5TH AND VIRGINIA

Proposed MUP #3018037

# SECTION 02. RESPONSE TO EDG

6(D) NORTHWEST ALLEY CORNER /

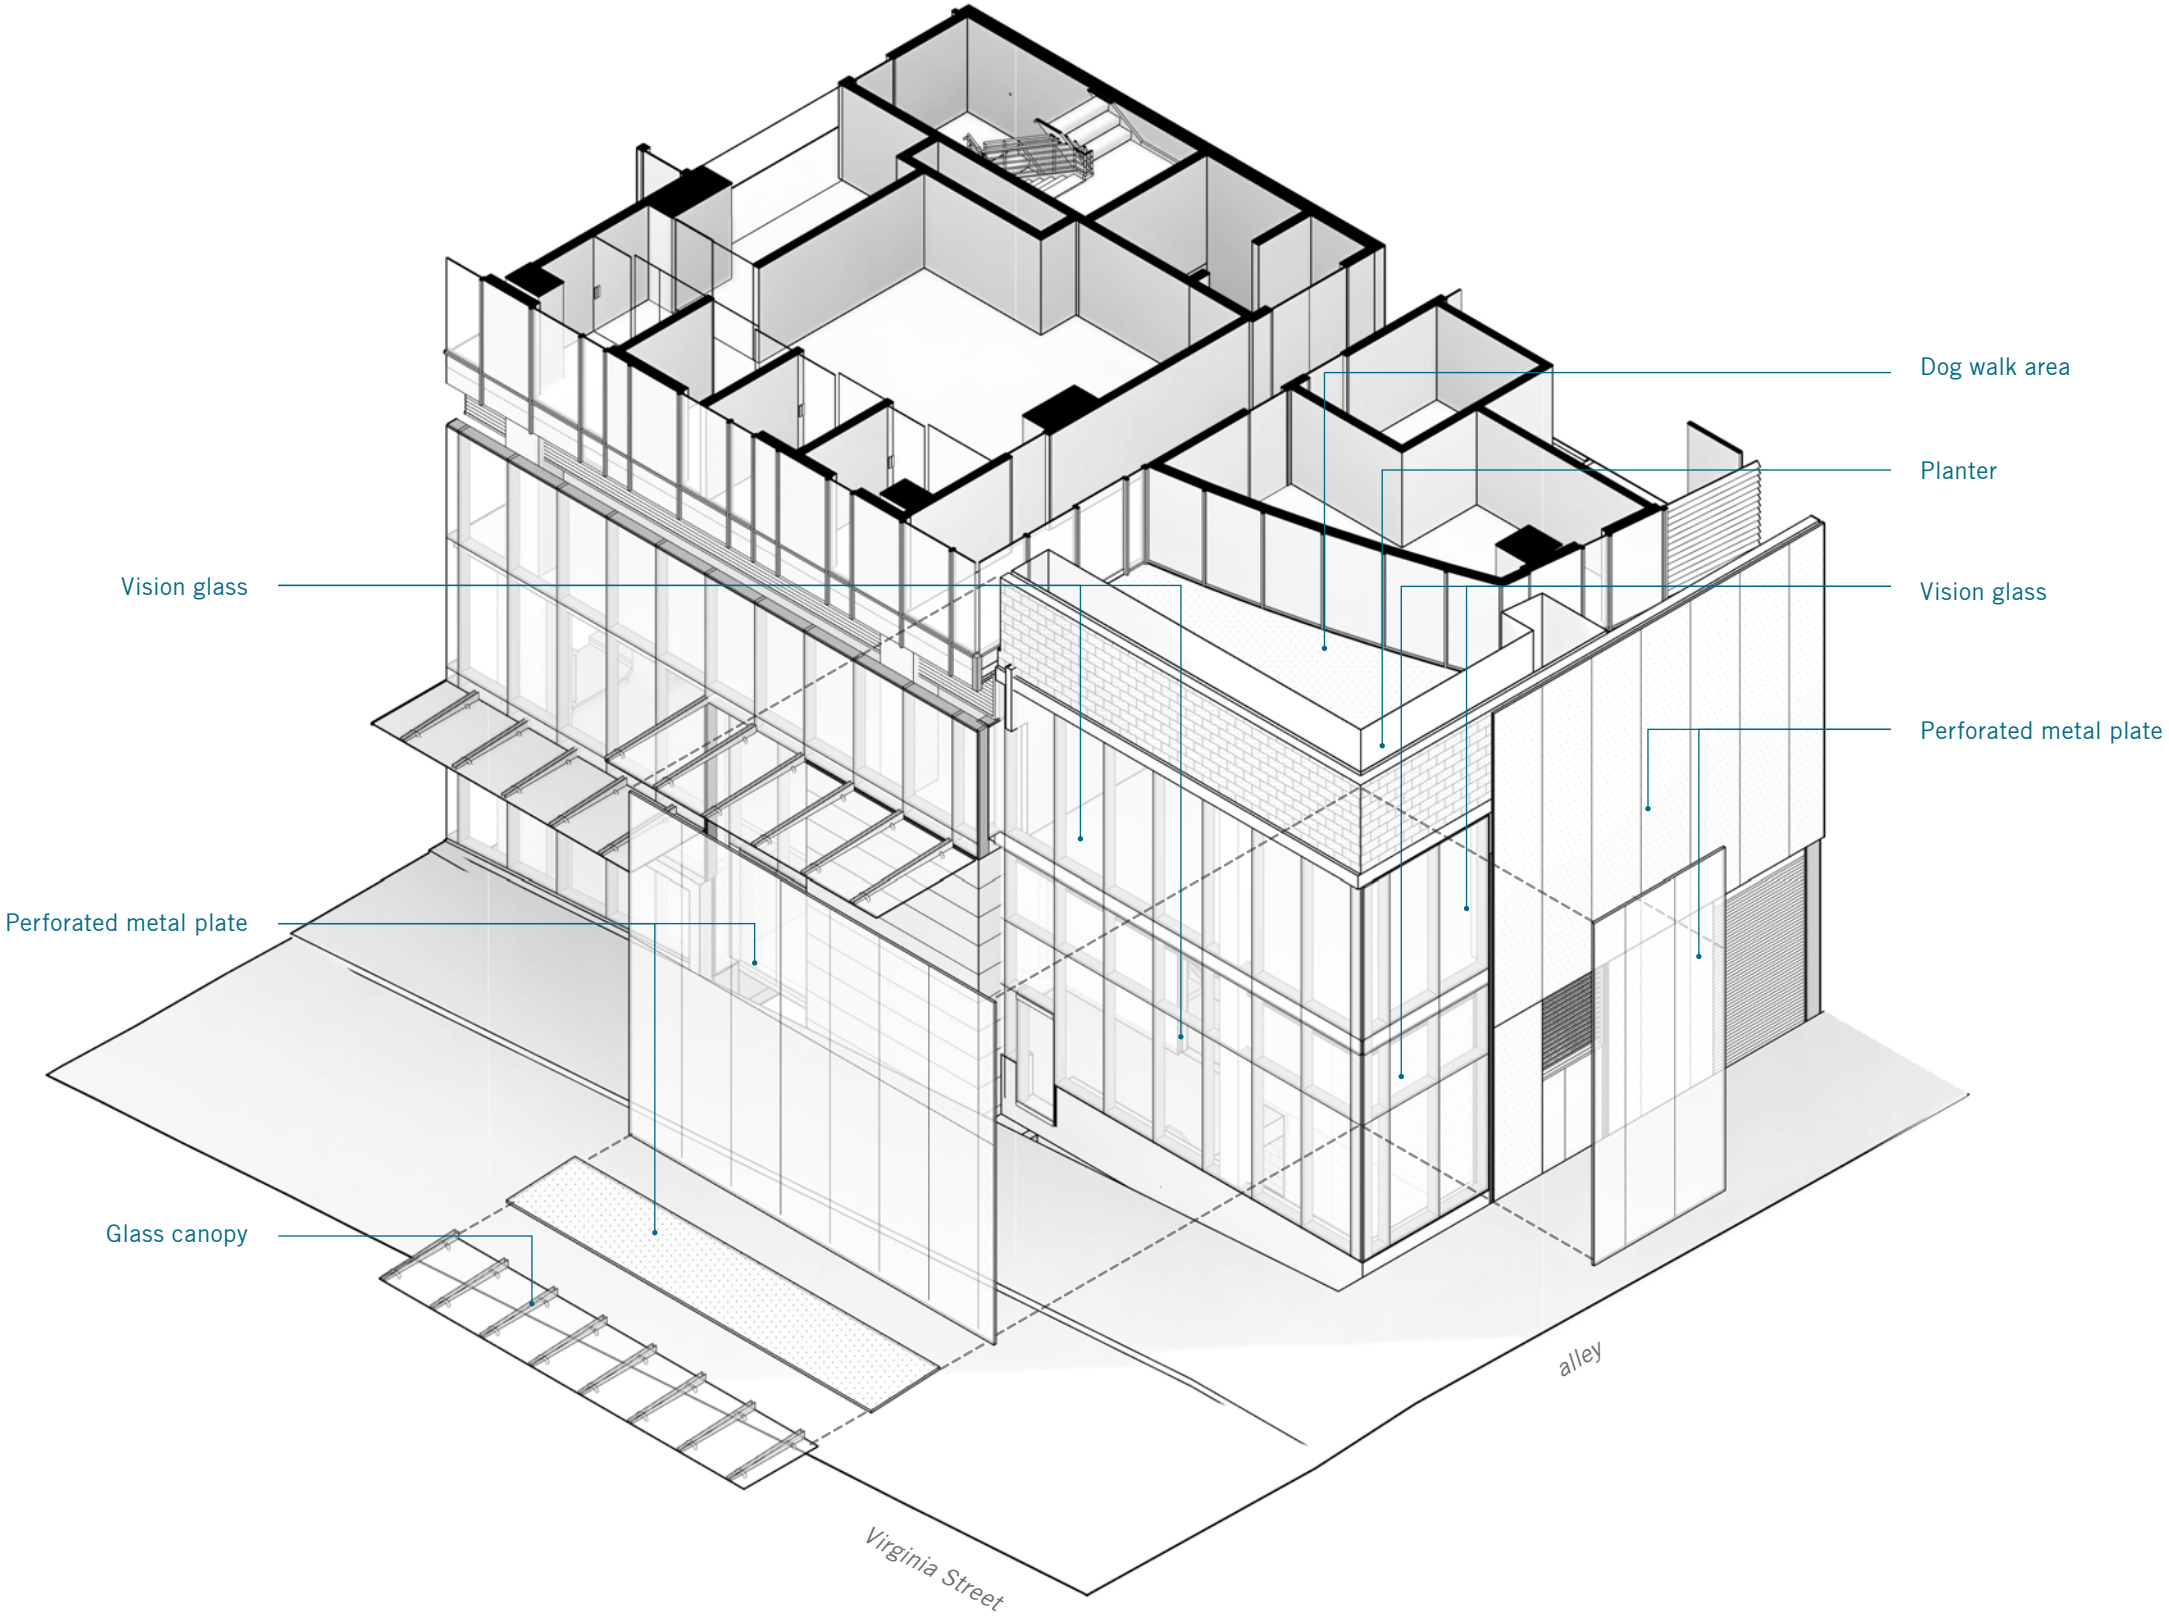
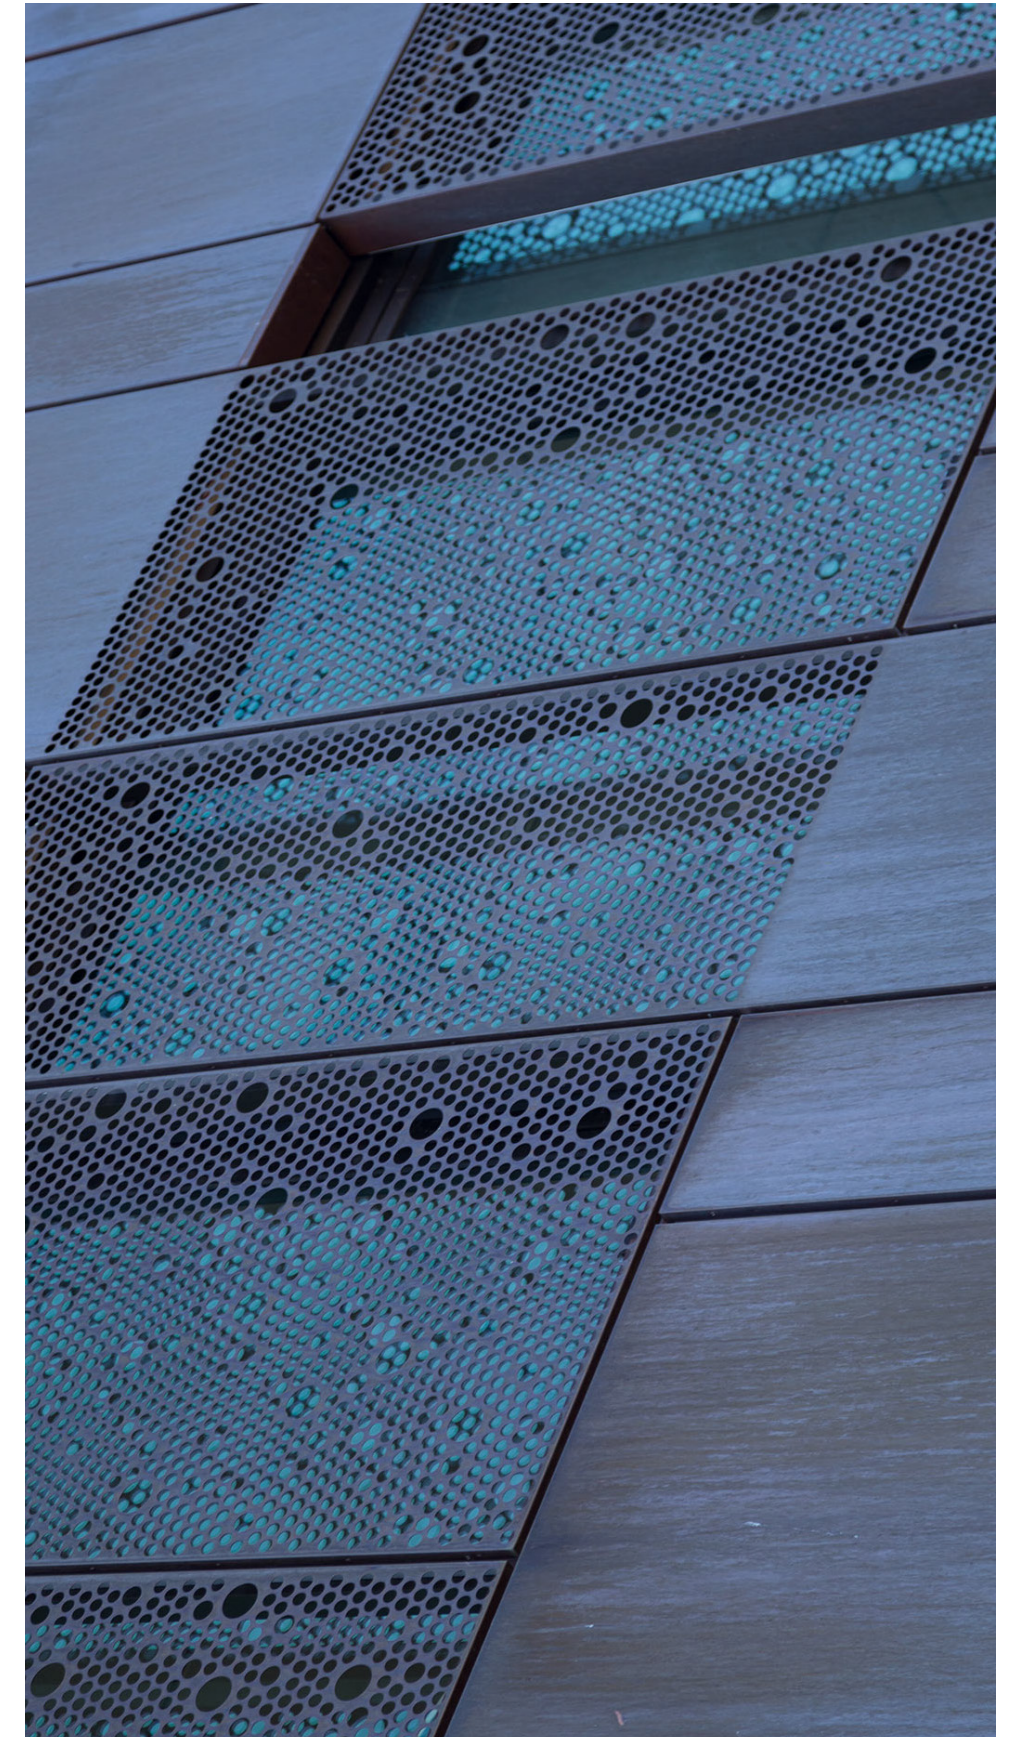
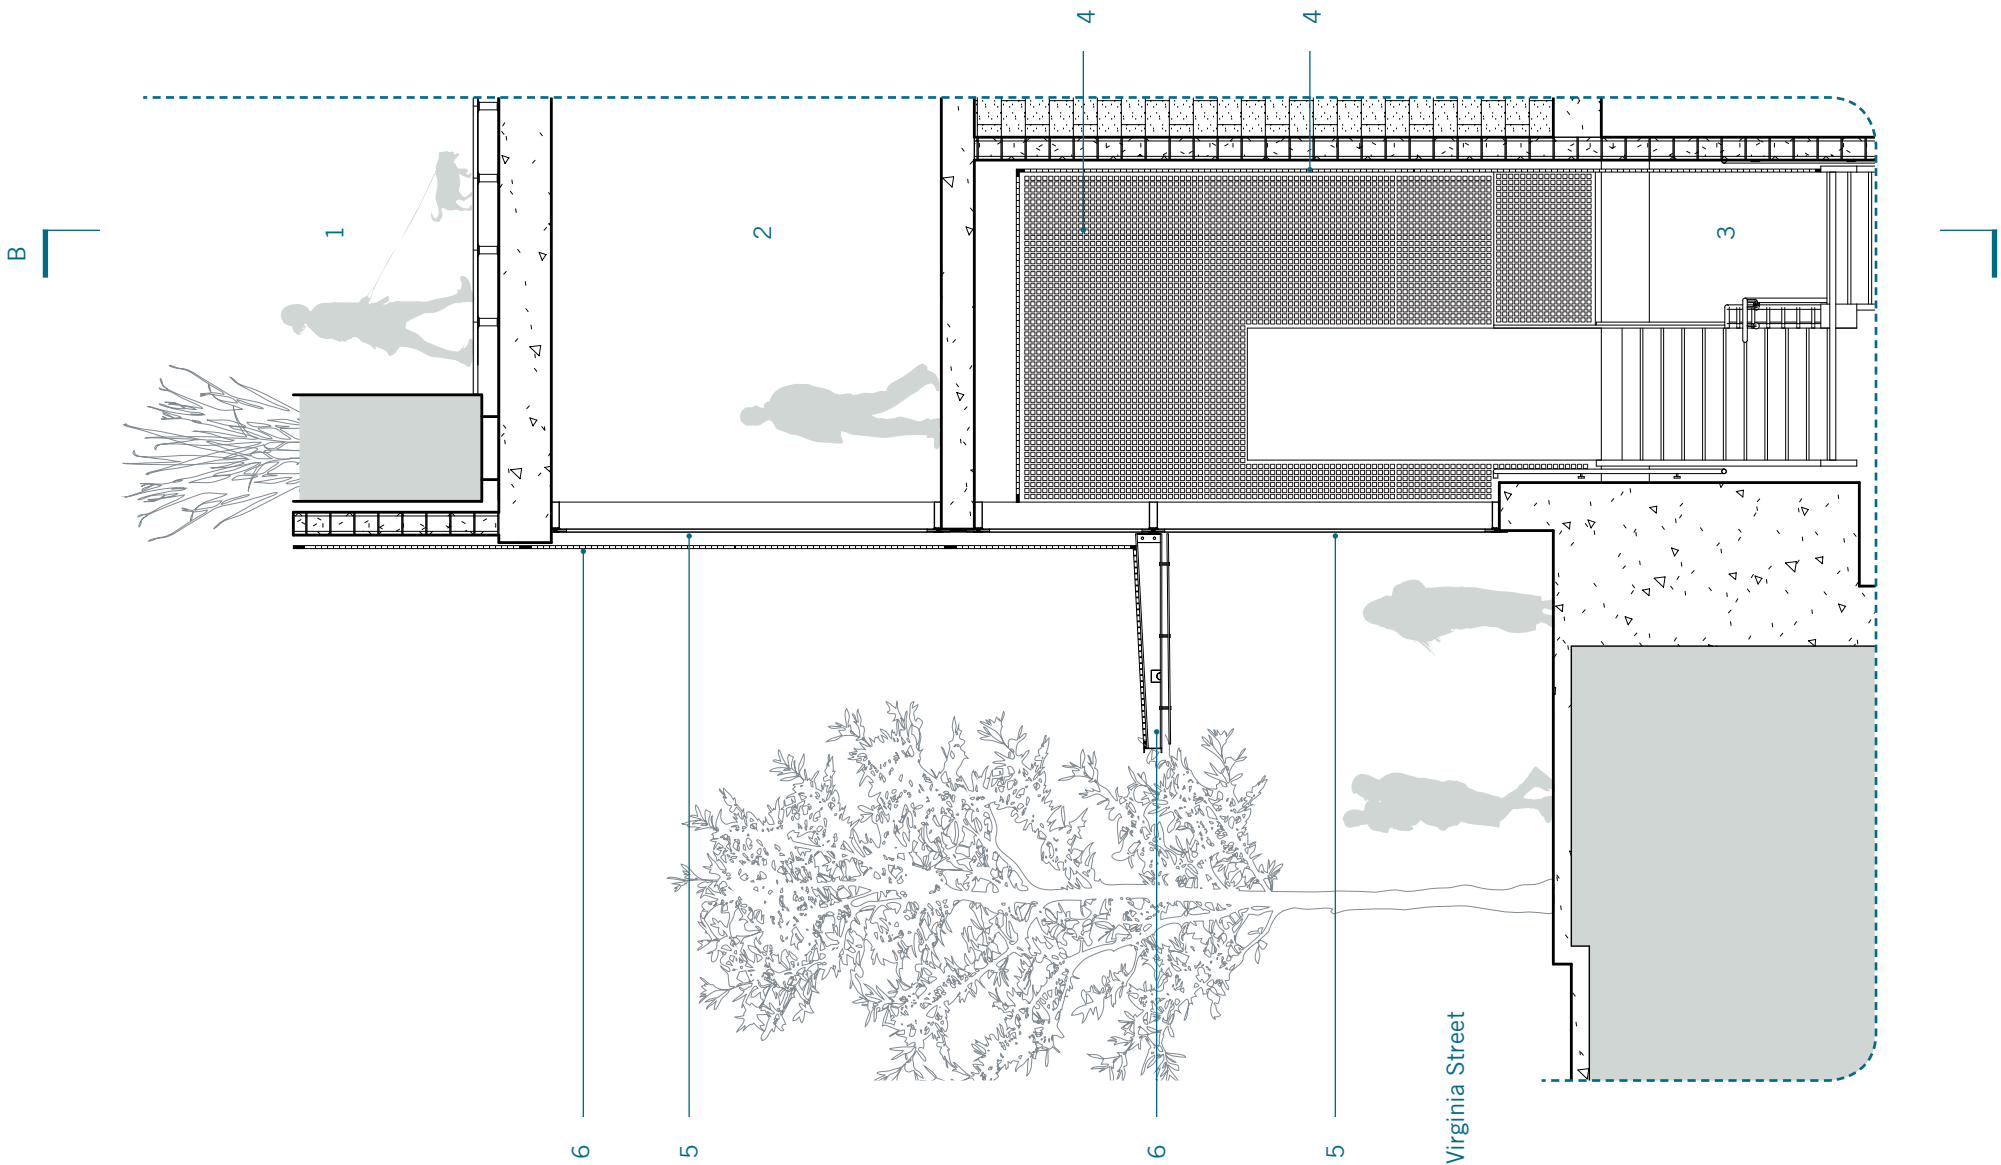
The Board agreed the west half of the Virginia frontage and the alley corner were far too blank as shown on pg 60, and regardless of proposed layering strategies, should show more transparency at the street and wrapping the corner, such as glass walls at the staff, security and corner stair shown on page 42. Shifted and perforated loading doors have potential, and more opaque layering techniques are acceptable on the southern part of the alley façade, beyond the part visible to Virginia. (C3, C6)

The northwest alley corner has been modified to maximize transparency into the security, staff, and south stair areas that front this portion of Virginia. Additional glazing has been introduced at the corner of the alley, which is visible from Virginia Street. The perforated panel 'layer' to the layered facade system has been raised to above the canopy line, and the perforated panels have been extended into the interior as a backlit layer to enhance the "inside/outside" reading of this space and create a highly transparent and interesting 'lantern' at the corner, while accommodating code required functions.
